Minutes
of
85th PCC Meeting

MINUTES OF 85TH PROTECTION SUB-COMMITTEE MEETING HELD AT ERPC, KOLKATA ON 19.11.2019 (TUESDAY) AT 11:00 HOURS

Figure 1: Three phase voltage recorded at Ranchi during the multiple tripping event at Ranchi at 04:26 hrs on 02-09-19

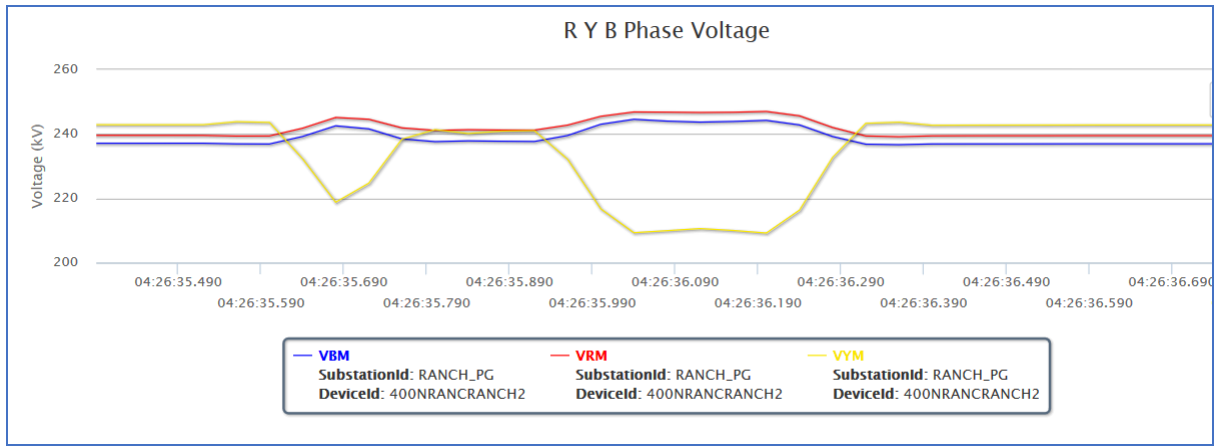
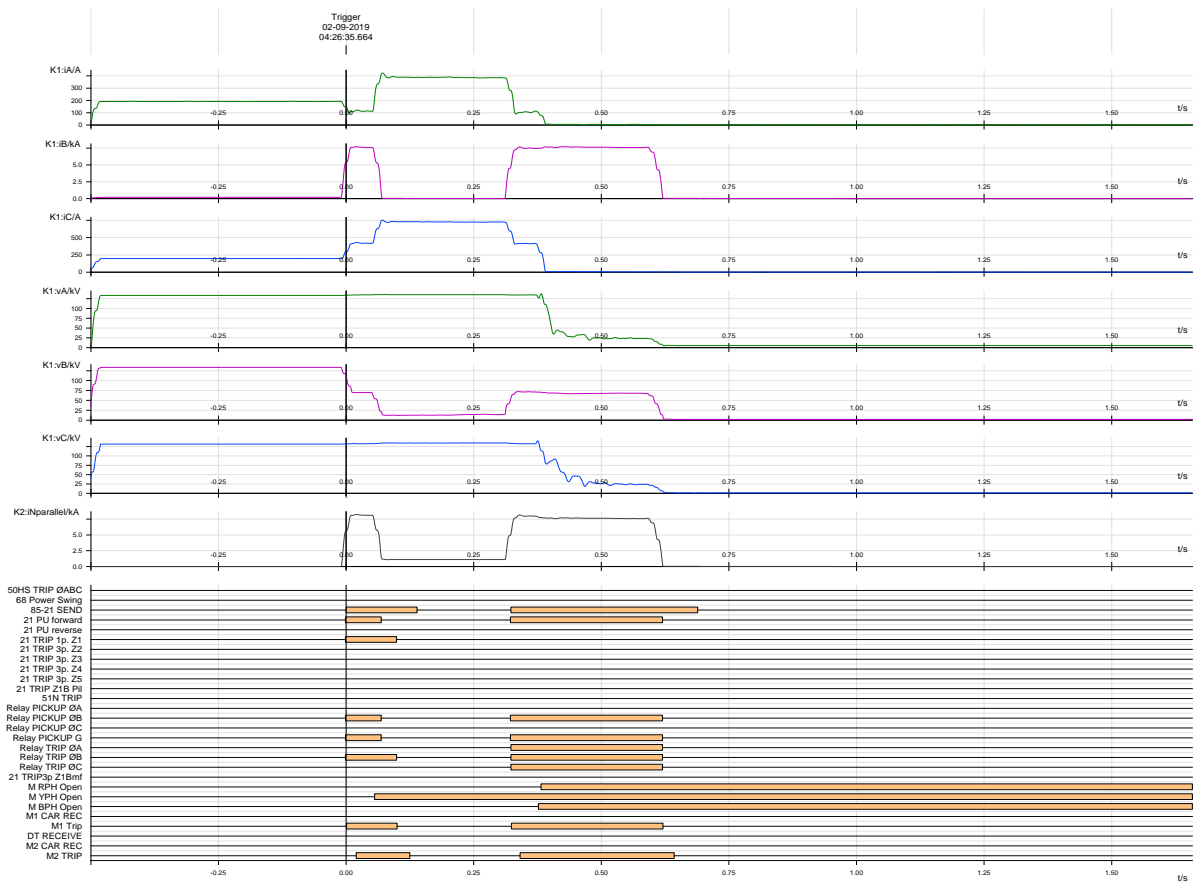
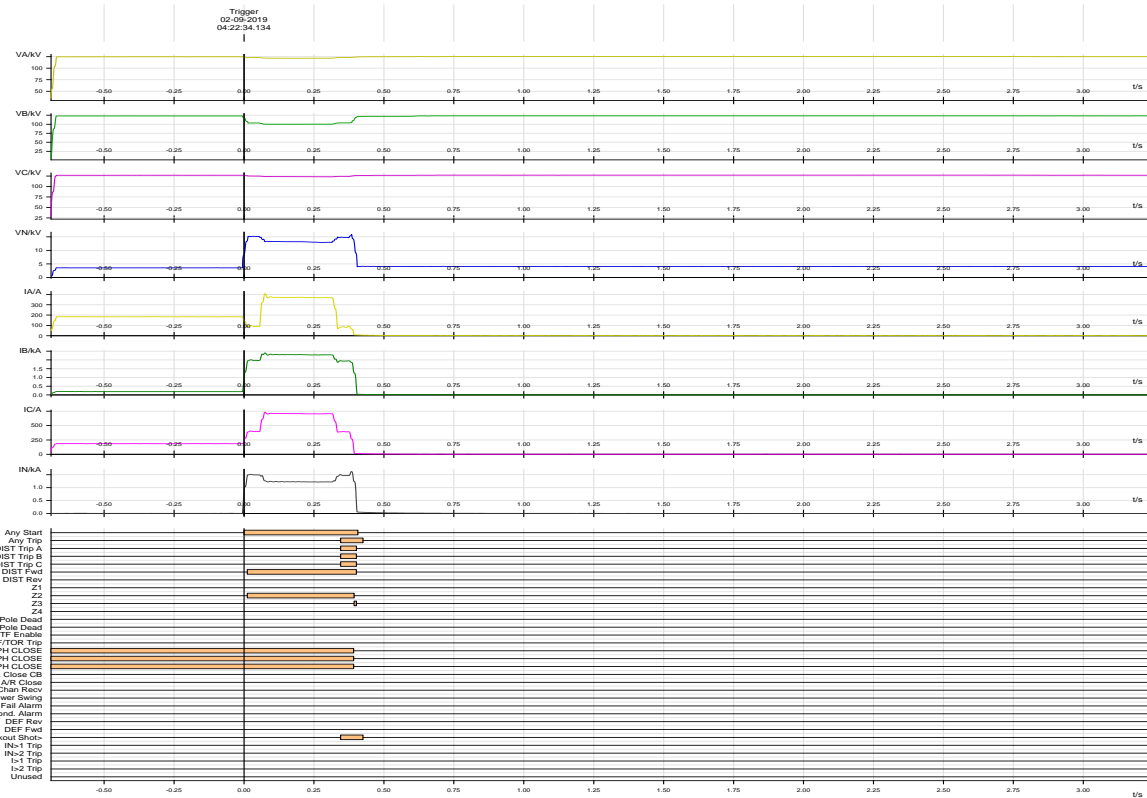
As per PMU data captured at Ranchi, two voltage dip were captured at around 04:26:35.600 hrs and at around 04:26:35.890 hrs. Though first fault was cleared within 100 ms, second fault was cleared after 350 ms. As per DR recorded at Ranchi end of 220 kV Ranchi – Chandil S/C, Y-N fault occurred at 04:26:35.664 hrs which got cleared from both sides within 100 ms. After 250 ms, Y pole breaker at Ranchi end auto-reclosed and tripped again as the fault was persisting at that time. During this time fault was cleared after 300 ms. No zonal protection or TOR operation was recorded in DR.

POWERGRID ER-I may increase the dead time of auto-reclose operation and share the reason for non-operation of any TOR protection at the time of reclose of the breaker. POWERGRID ER-I and JUSNL may share the reason for non-receipt of carrier at Chandil end.

Powergrid informed that Y-ph breaker restrike was observed after 300 ms. The breaker has been replaced.

Figure 4: Three phase voltage recorded at Ranchi during the multiple tripping event at Kolaghat Thermal Power Plant at 18:17 hrs on 25-10-2019

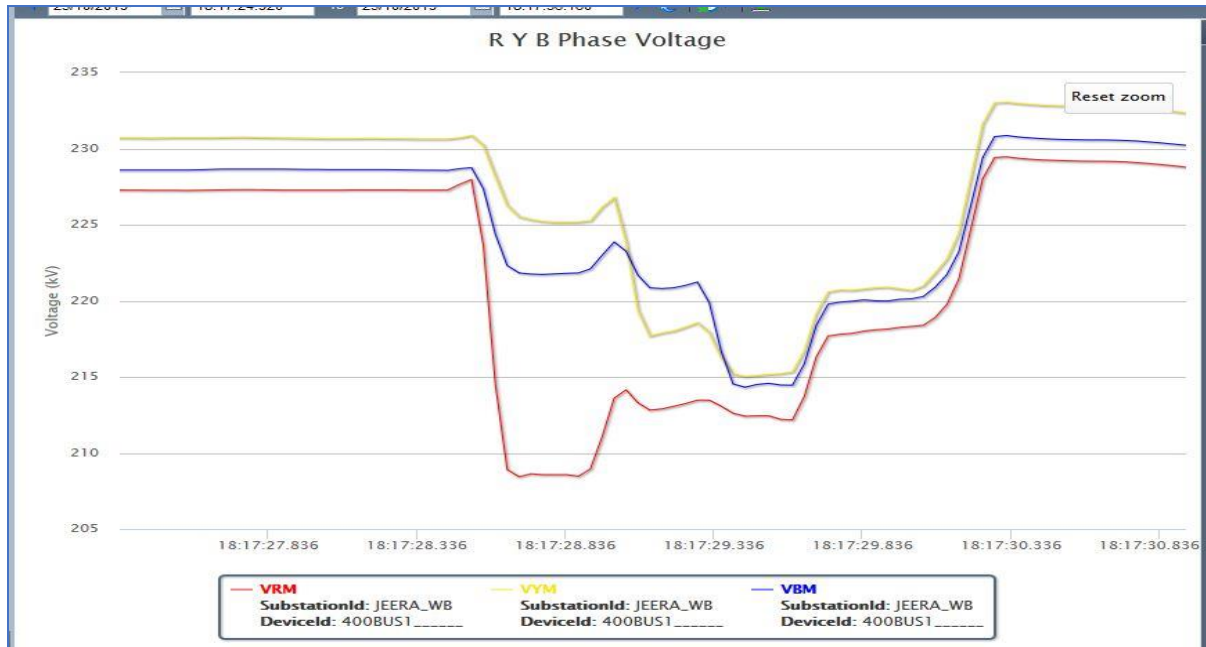
1. Tripping command was initiated first from 400 kV side of 400/220 kV ICTs for the fault in 132 kV side. Reason for non-tripping of any relay at 132 kV level may be explained though Z-IV picked up for 132 kV Tamluk #2, Uluberia and Bagnan feeders and O/C picked up for 220/132 kV ICTs from 220 kV side. This fault should be covered in bus bar differential protection. Due to unavailability of bus bar protection, fault was to be cleared from 400 kV and 220 kV level. **As per clause 45.2.vii of CEA Regulation: Measures relating to Safety and Electric Supply 2010, bus bar protection is to be present at 132 kV level also.**
2. Tripping of 400/220 kV ICTs before 220/132 kV ICTs may be investigated.

It was informed that the SPS for load shedding had been operated and tripped the 400/220kV ICTs at Kolaghat.

PCC advised WBSETCL to keep the SPS time setting greater than protection relay time setting to avoid unwanted tripping and should ensure proper relay coordination between 400/220kV ICTs and 220/132kV ATRs.

Figure 5 Jorethang end DR on 04/11/19 for 220 kV Jorethang-New melli line

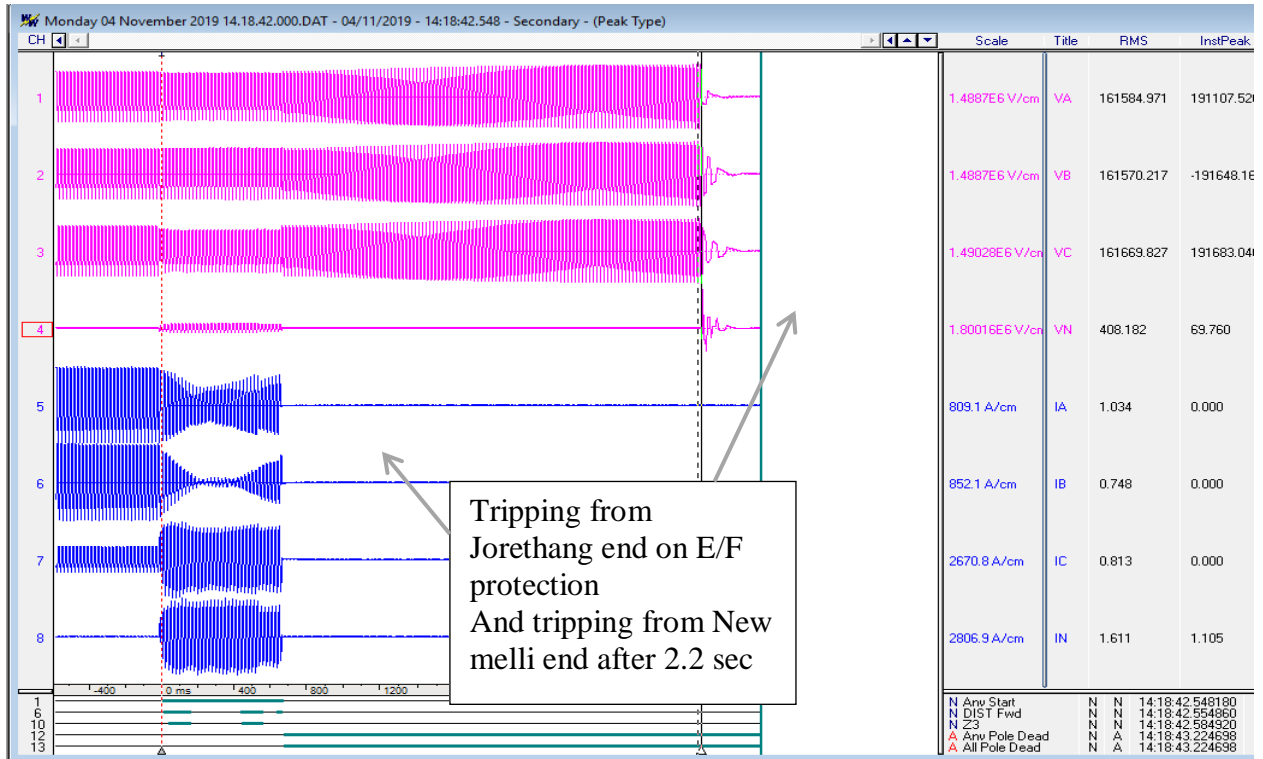
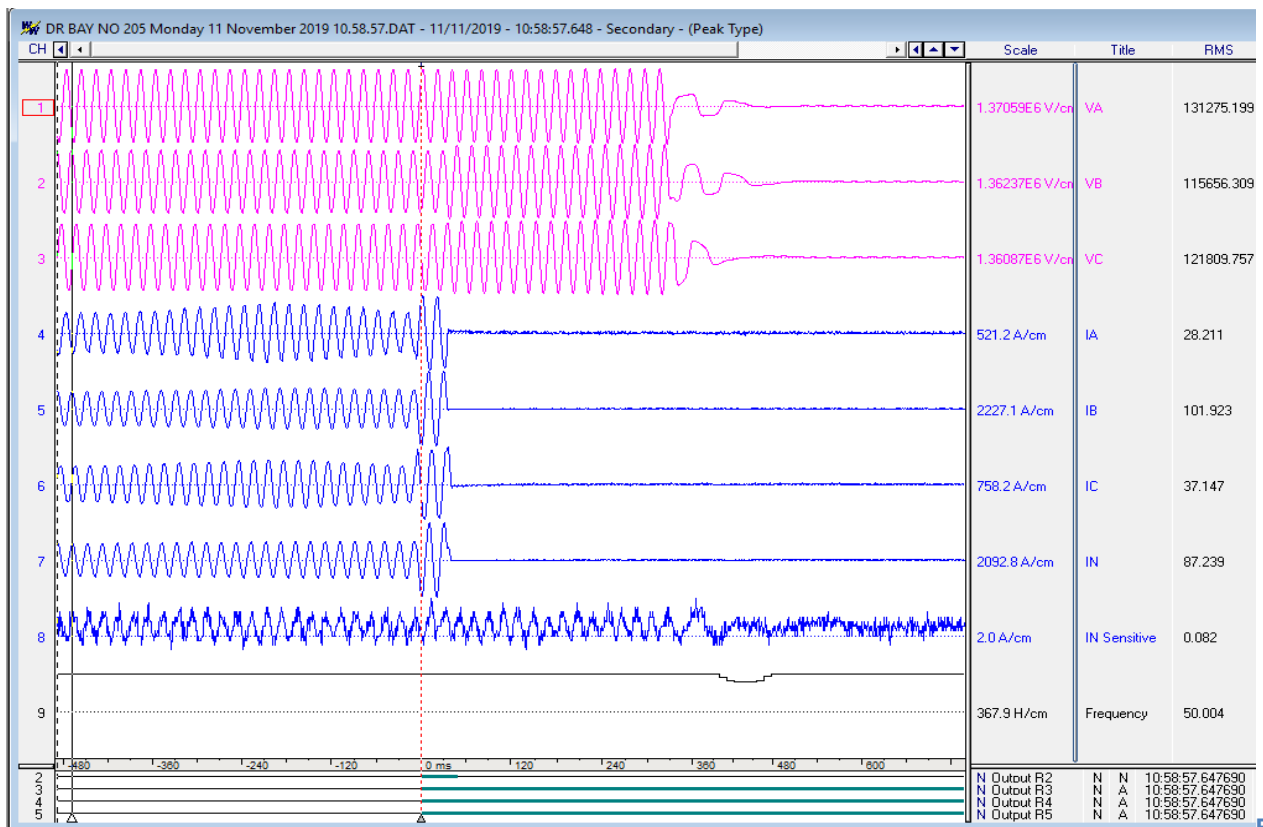
On 04/11/19 at 14:18 hrs Successful A/R took place on 400 kV Rangpo-Kishanganj line. At the same time 220 kV Jorethang-New melli tripped on E/F protection from Jorethang end and after another 2.2 sec it tripped from other end. Such overreaching was also taken place in past and PCC advised to revise the setting and do proper coordination. JLHEP via mail confirmed that revised setting is implemented on 07/11/19.

However on 11/11/19 again during successful A/R of 400 kV Rangpo-Kishanganj 220 kV Jorethang-New melli tripped. So Jorethang and POWERGRID are requested to review the setting again and ensure proper coordination.

Jorethang vide mail informed that they are unable to set the relay settings of DEF of backup protection and shared the settings with ERPC Secretariat. It was decided that the settings would be reviewed in coordination with PRDC.
